MODEL	SUBJECT		22/03/96
Range Rover Classic	Stalling/Poor Idle/Surging		19/03/96/US
Discovery	AFFECTED VEHICLES		
Discovery	LP	661835 to 663534	
Defender 90	LJ	152765 to 164227	
	LJ	500000 to 515006	
	LD	965085 to 980154

DETAIL
During mid to late 1995 a number of faulty stepper motor (Idle Air Control Valve) castings found their way into production of 14CUX vehicles and the parts supply. This bulletin will help identify the faulty castings and also identify the problems they cause. Problems encountered are as follows:
The restriction caused by the faulty casting affects the idle speed control, especially on cold start.

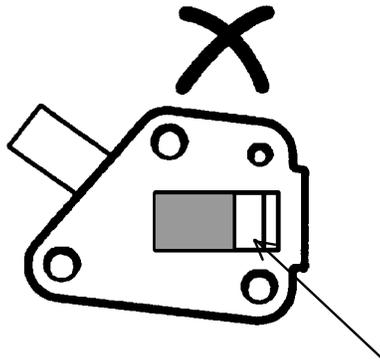
PROCEDURE
Refer to the Workshop Manual section 19 "Idle Air Control Valve."
Description
1. The aperture on faulty castings is approximately 0.315x0.118 in(8x3mm) (on normal castings the aperture should be 0.433x0.433 in(11x11mm)).
2. Corners marked in illustration are square on faulty castings (normally they should be rounded).
3. On good castings, IACV spring is clearly visible, but more difficult to see on faulty castings.
What to Do
If above symptoms are present and a IACV housing is fitted to vehicle, remove housing, remove stepper motor from housing and file down housing aperture to meet specifications as outlined above. When the IACV is re-fitted use Loctite 242 on the threads before installing. **Remember to RESET IDLE on a fully warm engine and transmission.**

Incorrect aperture size of 3mmX8mm.
